STAFF RECOMMENDATION 123 Blackburn Avenue February 18, 2015

Application: New construction-addition and outbuilding
District: Belle Meade Links Triangle Neighborhood Conservation Zoning Overlay
Council District: 23
Map and Parcel Number: 13001017900
Applicant: Kaitlyn Smous, Allard Ward Architects, LLC
Project Lead: Paul Hoffman, paul.hoffman@nashville.gov

Description of Project: This application is for construction of a rear addition to the home, and a garage outbuilding.

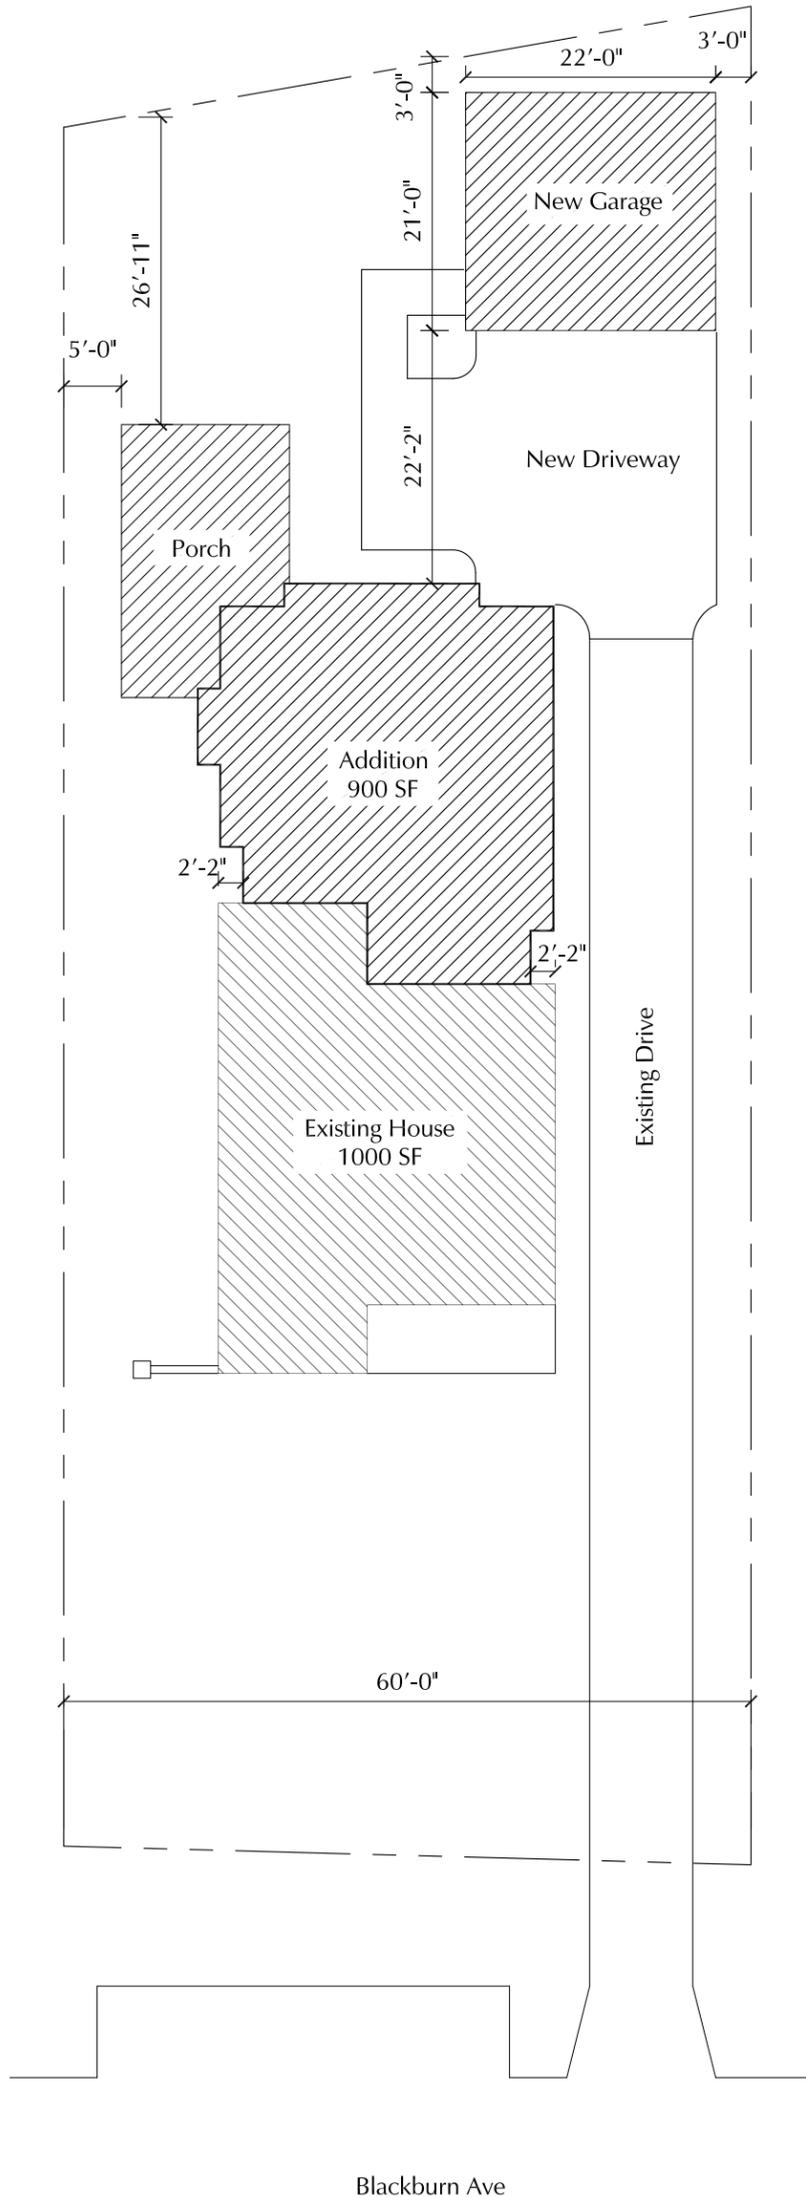
Outbuildings: Windows & Doors: *For street-facing facades, garages with more than one-bay should have multiple single doors rather than one large door to accommodate more than one bay.*

Staff recommends as a condition of approval that the garage have two doors instead of one large door.

AD1.1

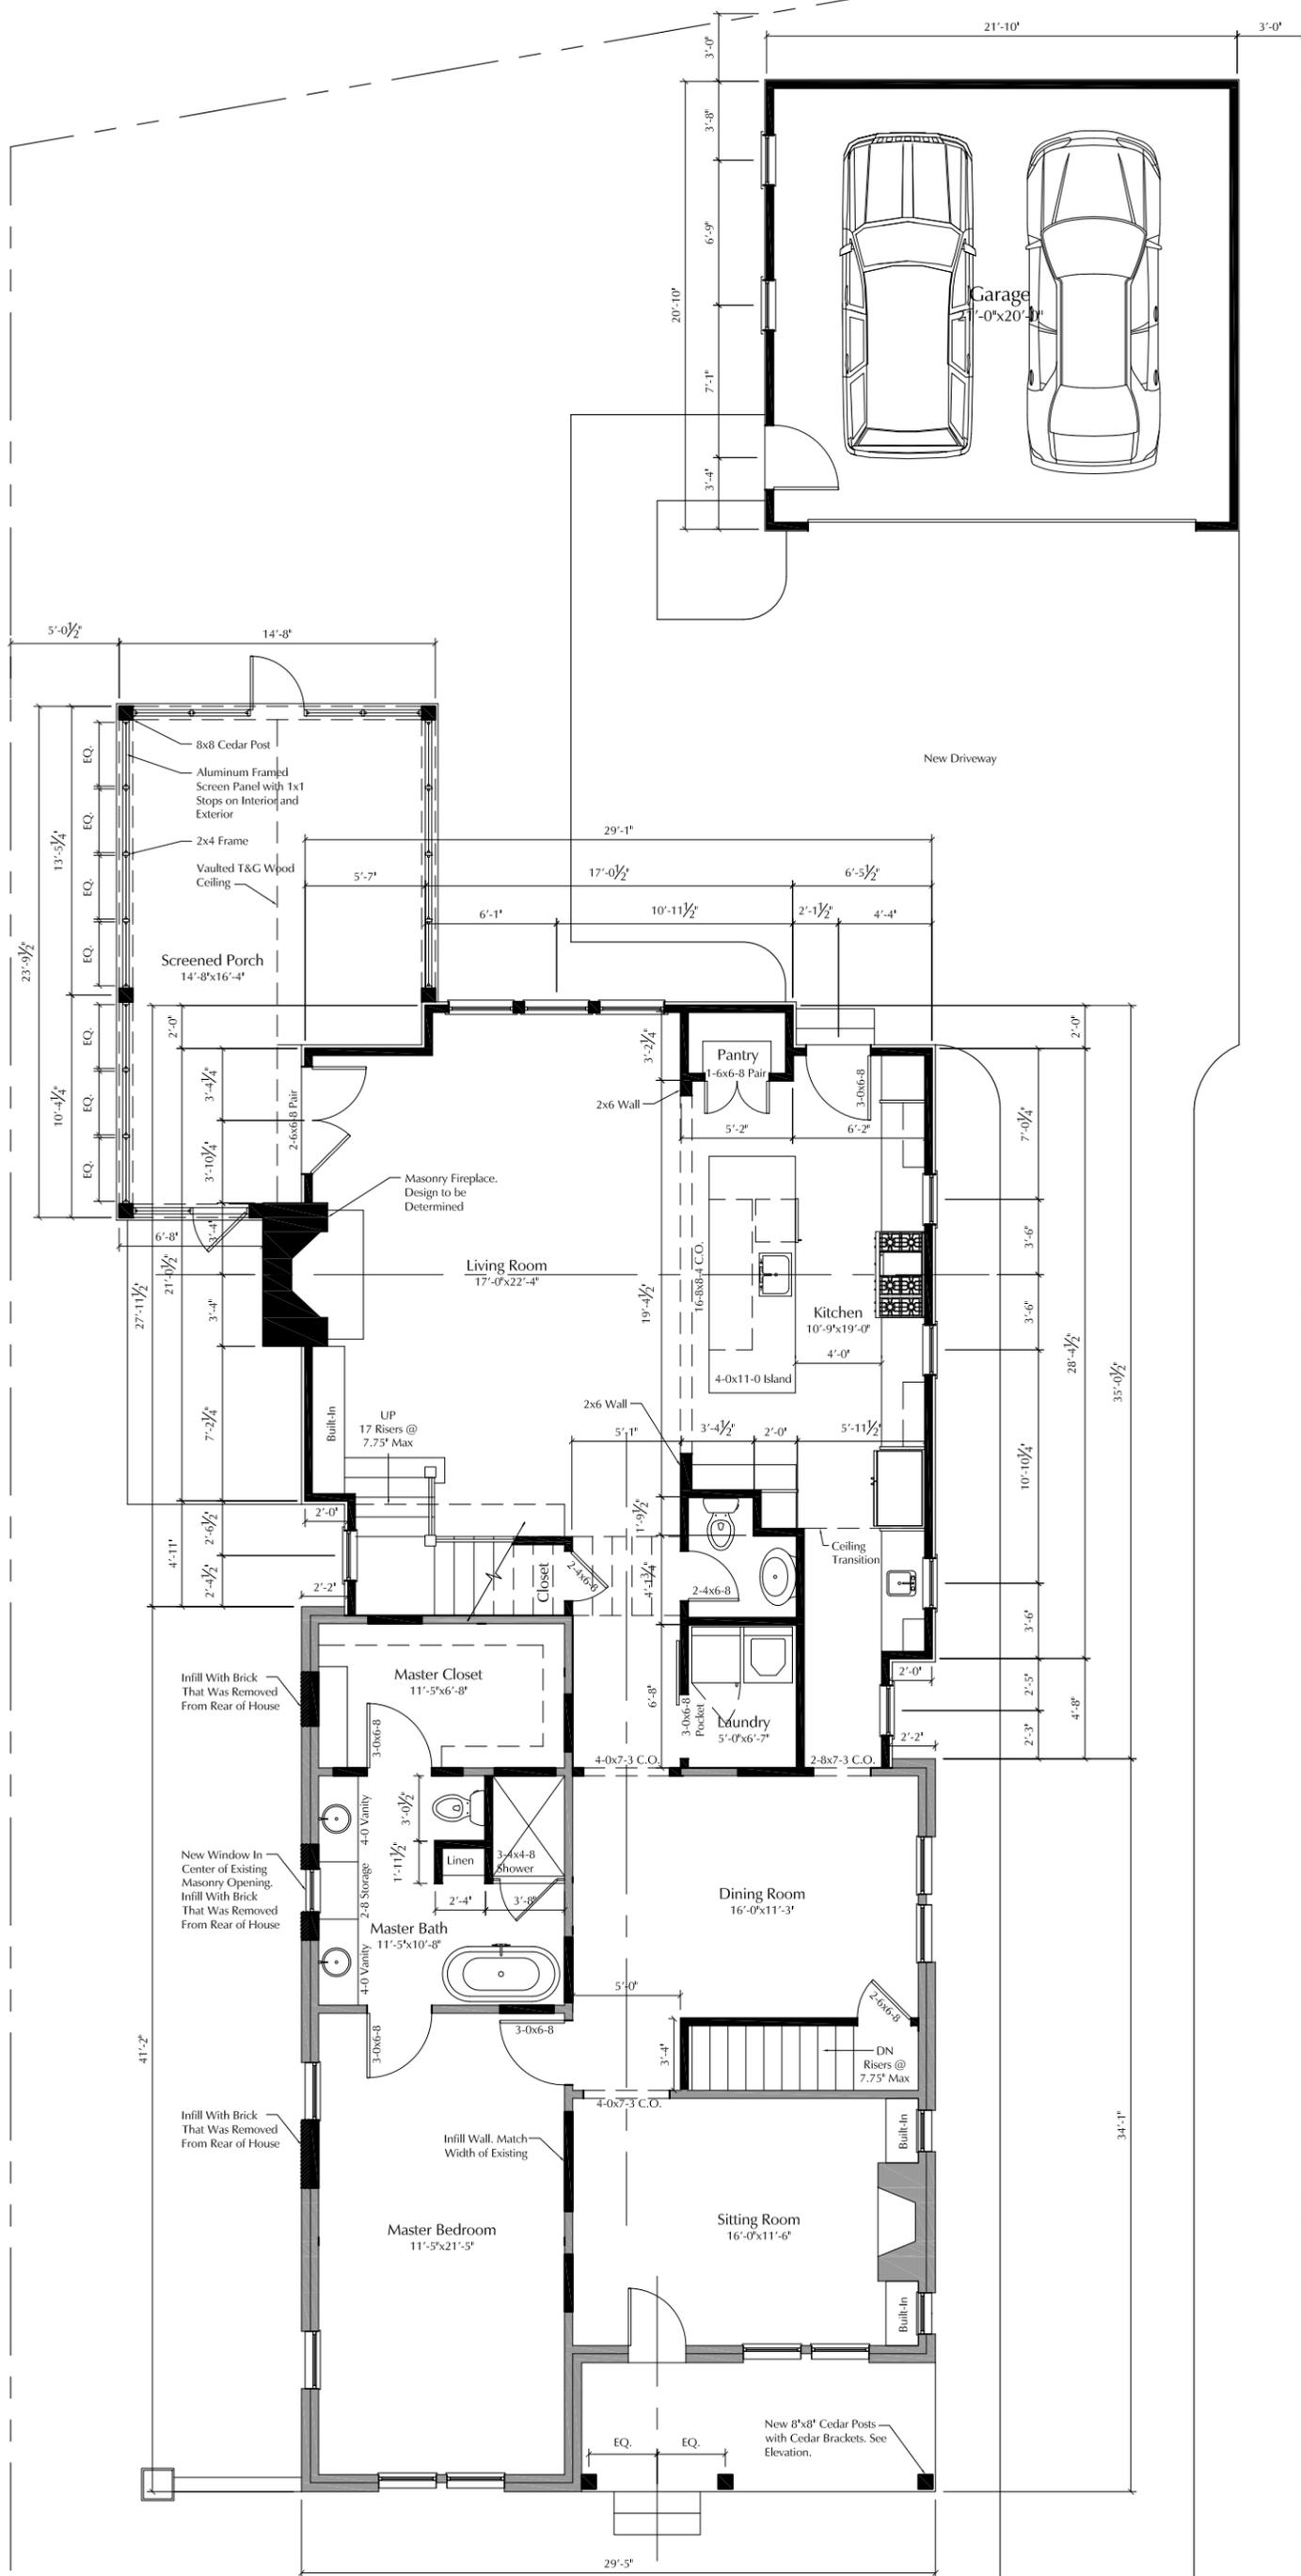
Demolition: The project's demolition plan includes removal of most of the existing rear wall, excepting the corners. Metal columns on the front porch will also be removed; these are not original to the house. Staff finds that the portion of the house proposed for demolition does not contribute to the architectural or historical character and significance of the district. Therefore, this partial demolition meets section IV.B.2 for appropriate demolition and does not meet section IV.B.1 for inappropriate demolition.

Drawings:
 West Elevation
 East Elevation
 Date: 01.29.15

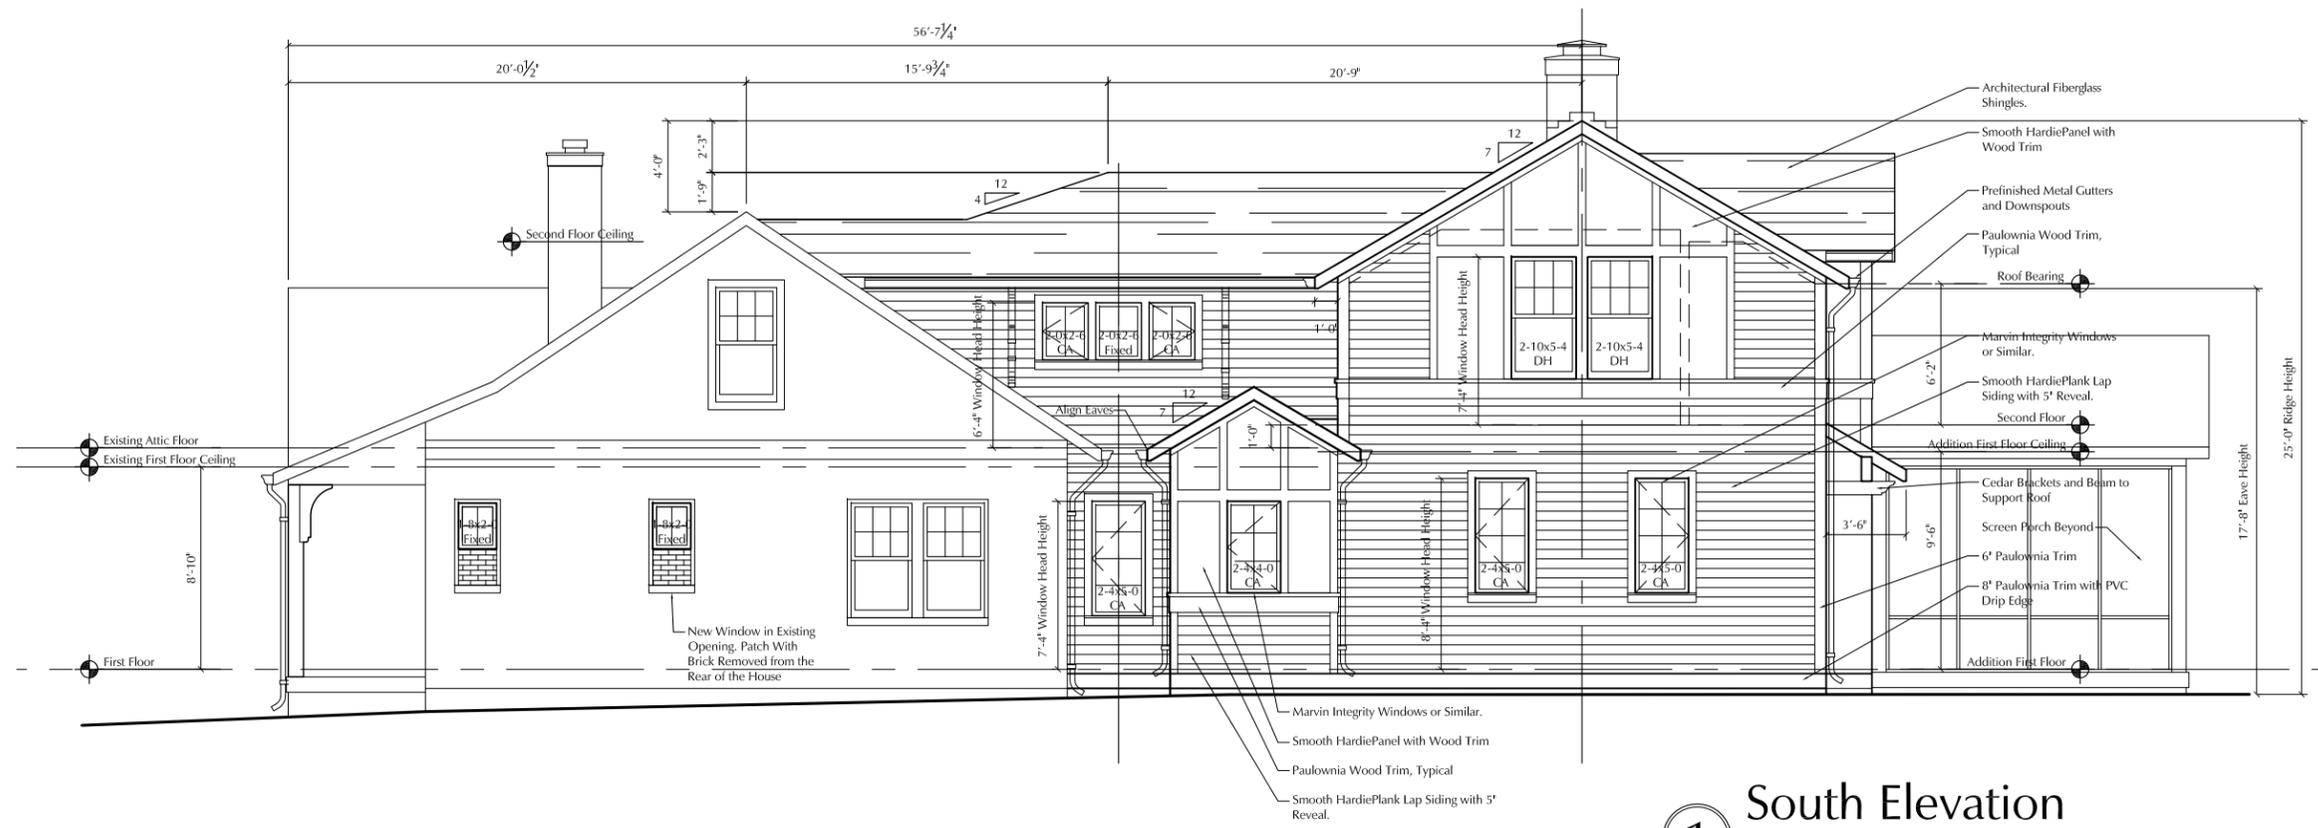
Proportion and Rhythm of Openings: The plans submitted indicate altering two existing window openings on the left side, and three openings on the right. The windows on the proposed addition are all generally twice as tall as they are wide, thereby meeting the historic proportions of openings. There are no large expanses of wall space without a window or door opening. Staff finds the project's proportion and rhythm of openings to meet Section II.B.1.g.

1. That the existing window openings on the house forward of the midpoint remain as they are currently;
2. Staff approve windows and garage doors prior to purchase and installation;
3. Staff approve the roof color;
4. Staff approve a masonry sample for dimensions, color and texture;
5. If they are moved, HVAC or other utilities shall be located behind the house or on either side, beyond the mid-point of the house;
6. The garage have two individual garage doors, instead of one large door.
